***ADDENDUM***  
***TO***  
***FUNCTIONAL SERVICING REPORT***

**HILLSBURGH HEIGHTS INC.**  
**PROPOSED RESIDENTIAL SUBDIVISION**

**5916 TRAFALGAR ROAD NORTH**

# **1. RESPONSES TO THIRD SUBMISSION COMMENTS RELATING TO STORMWATER MANAGEMENT**

**DRAFT PLAN OF SUBDIVISION**  
 5916 TRAFALGAR ROAD NORTH  
 (PART OF LOT 26, CONCESSION 7  
 TOWN OF ERIN  
 COUNTY OF WELLINGTON  
 FILE No: 23T-21002, Z21-09

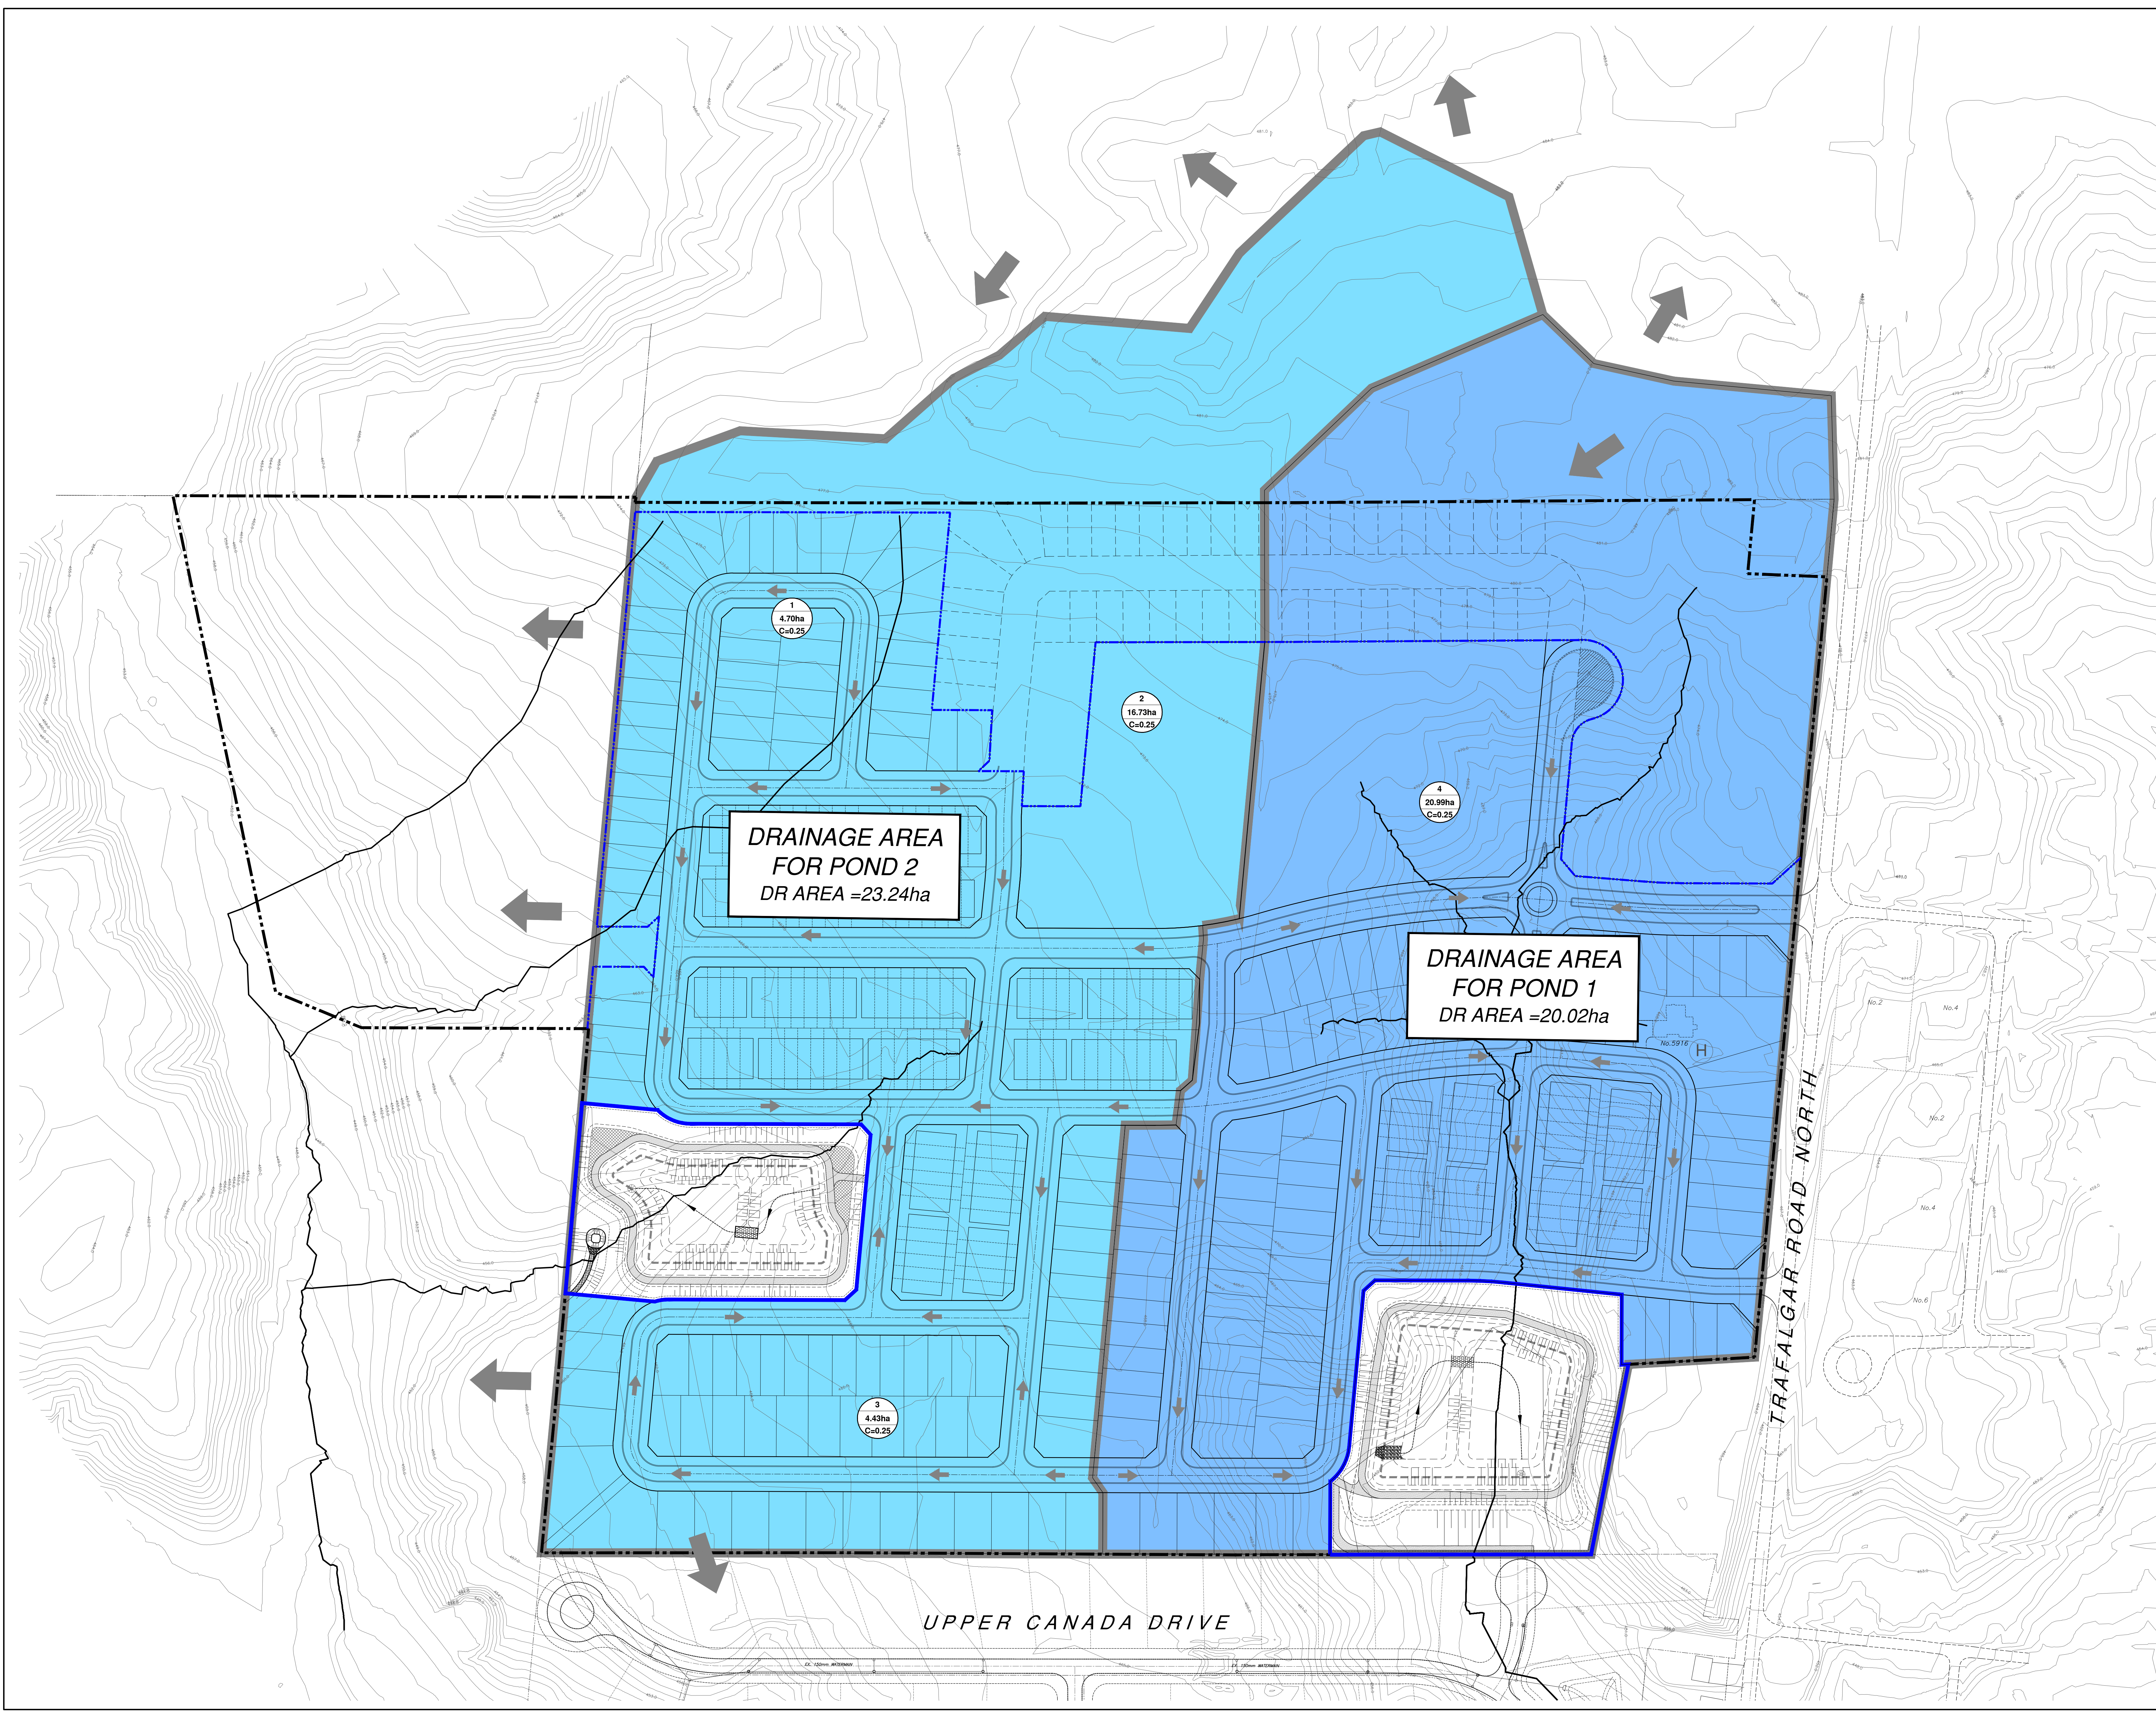
### **11. External Drainage Ditch - Block 15 Draft Plan Revision 8**

The 100 year flow from the upstream Drainage Area of 6.84 ha (Agricultural Land) is 1.4 m<sup>3</sup>/s. The capacity of the Diversion Ditch is 12.6 m<sup>3</sup>/s at a depth of 0.5m. Refer to attached Appendix I for calculations.

**PREDEVELOPMENT SWM POND DRAINAGE AREA PLAN**

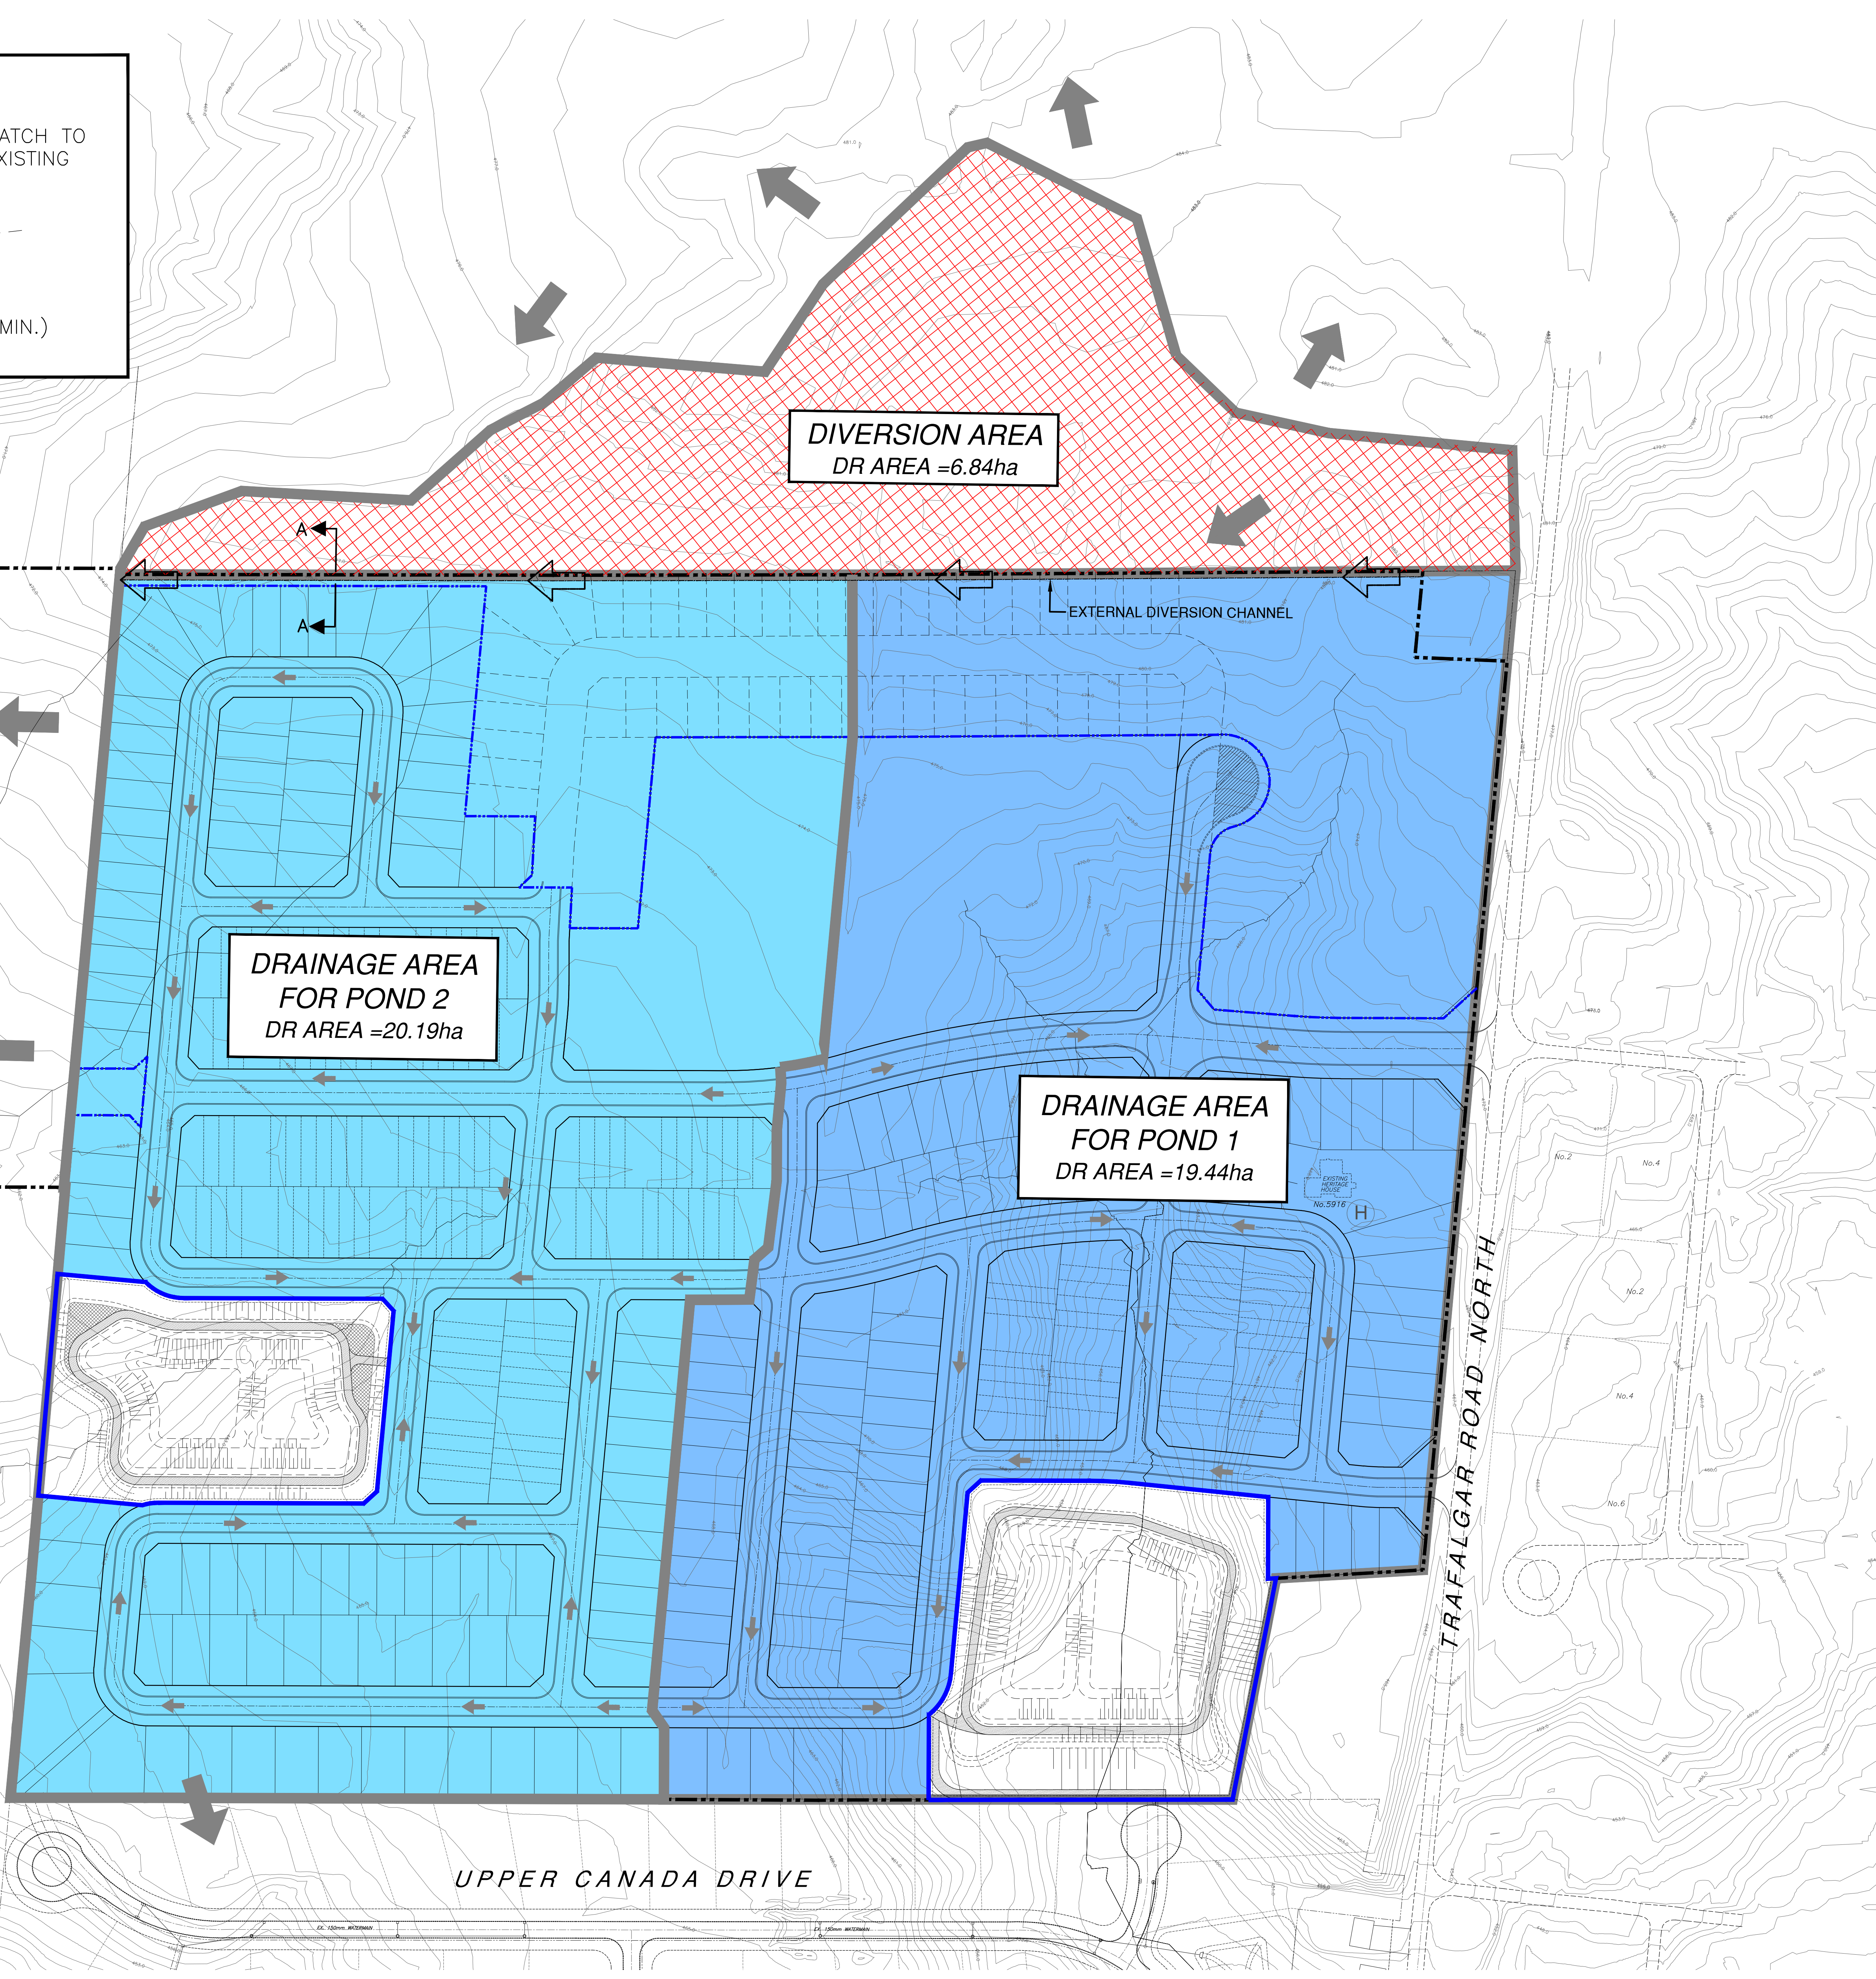
**Pre and Post Drainage Areas to SWM Pond No. 2**

The Pre-Development Drainage Area Plan as shown on Drawing PDR-1 shows that the Pre-Development Drainage Area to the downstream Wetland is 24.97 ha (including SWM pond area).
